Measure no.	Subject	
US 59123693-02	The windscreen is breaking away at the fastening points.	
Status date (mm/dd/yy)	Status	Organization
6/24/14	Accepted	US, MOT
Date created (mm/dd/yy)	Created by	PQM Problem reference
6/24/14	Christine Koehling	
Release date (mm/dd/yy)	Approved by	Dealer release
		Allow automatic release

All windscreens for the R 1200 GS (K50) and the R 1200 GS Adventure (K51) have been changed.

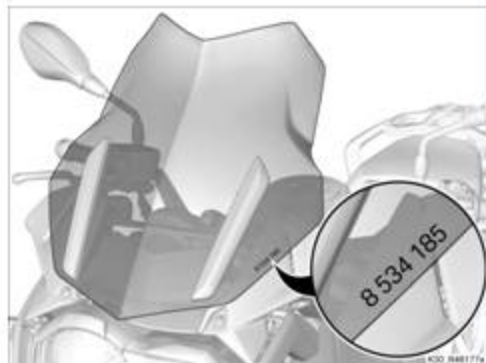
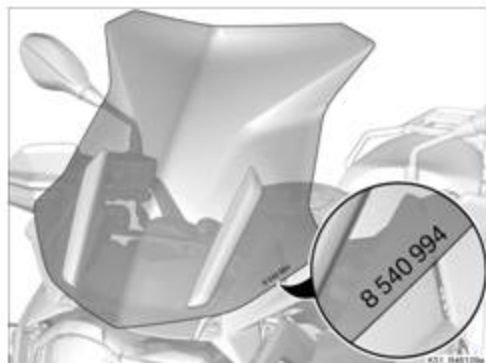
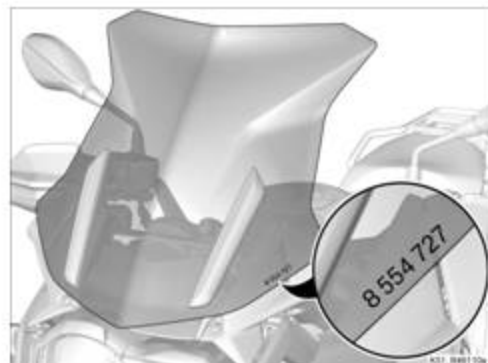
From 06/2014, new windscreens with a new fastening concept will be fitted at the factory.

The construction status can be identified by the part number on the windscreen.

See accompanying pictures.

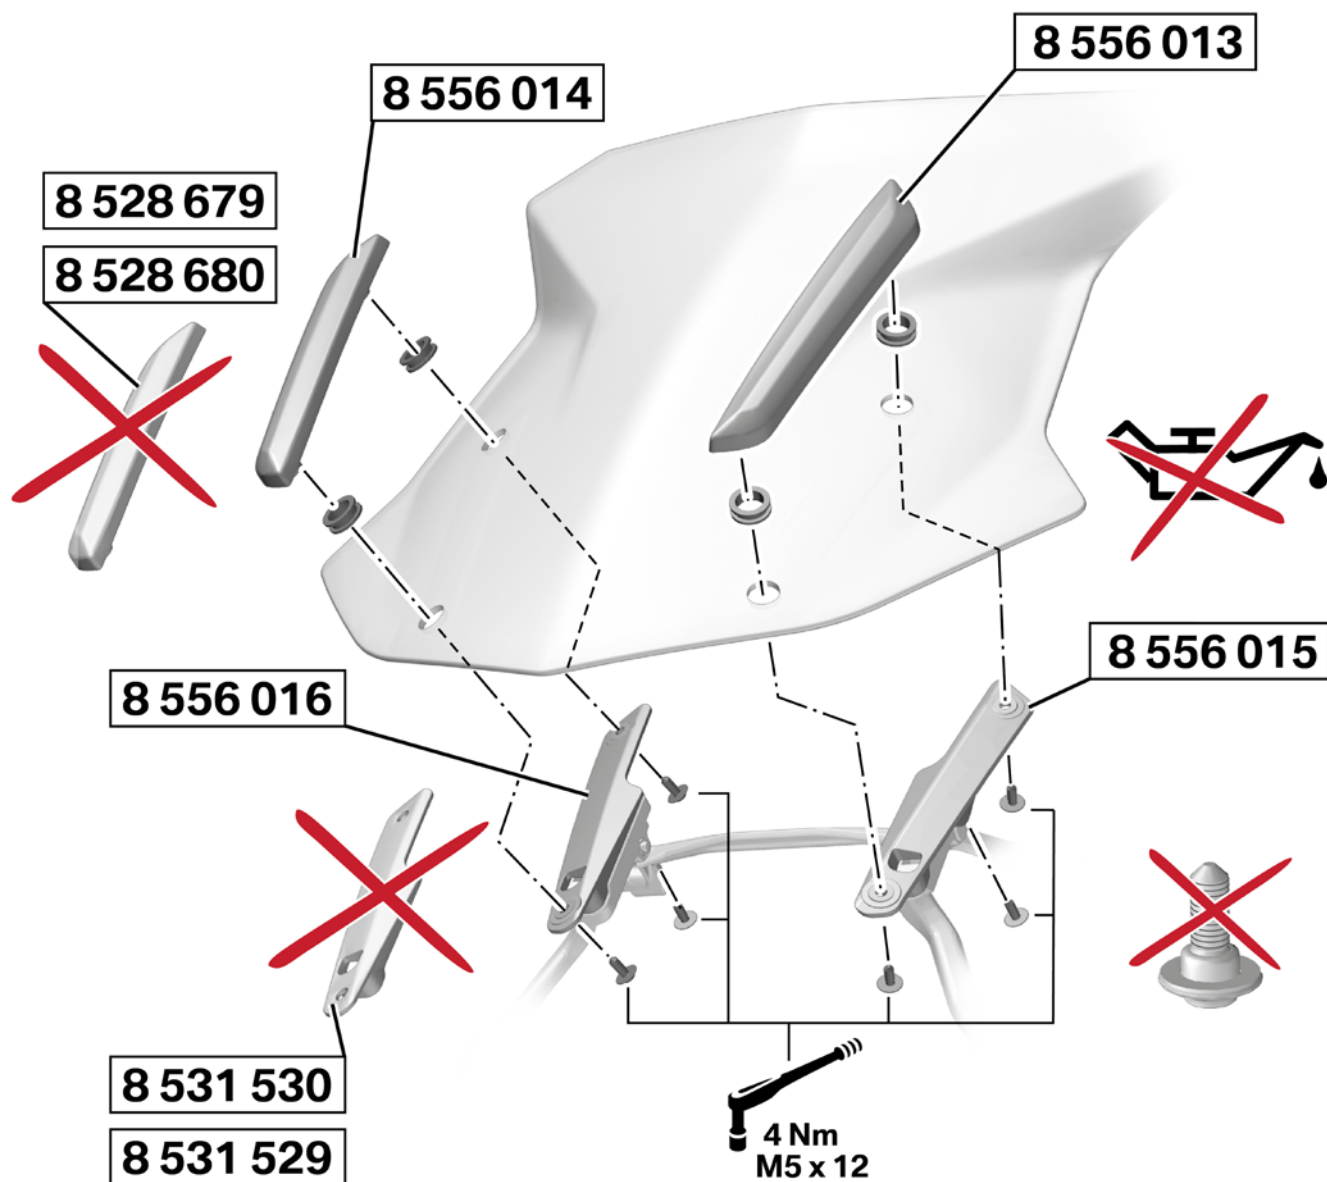
When repairing vehicles with the older construction status, the new windscreen must only be fitted in conjunction with all the fasteners listed below:

Fit in accordance with the accompanying diagram.

1 x left cover 8556013

1 x right cover 8556014

1 x left bracket 8556015

1 x right bracket 8556016

4 x grommets 8557871

6 x screws 8531936
